Classification	OS image specification comparison and Important notices for WP-8x4x				No.		
Author	Tunglu	Version	1.0.4	Date	2011/8/15	Page	1/11

WP-8x4x: Important notices and history of OS image

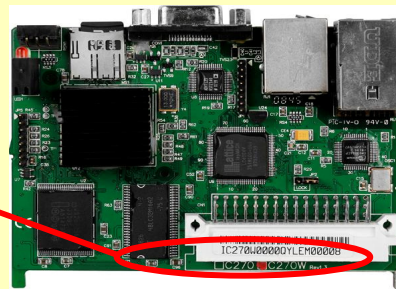
1. Changing the file system from FAT to TFAT will cause the System_Disk lost.
 - Update the OS by executing the .exe file: the System_Disk will be back up to the microSD before the updating, and be restored after the updating is done. The whole processes are performed automatically.
2. The Intel 95ns J3 Flash chip was phased out, WP-8x4x replaces it with a 105ns J3 Flash chip since 2010, April, 6th. But the new J3 Flash chip is not 100% compatible to the original one. Thus the OS and Eboot for WP-8x4x must be updated to version 1.5.0.1 and 1.2.0.1 to support both version of the Flash chip.

And please note, the older versions of OS and Eboot don't work on the WP-8x4x that is equipped with the new J3 Flash chips. Don't install the earlier OS and Eboot to it, else it will not boot.
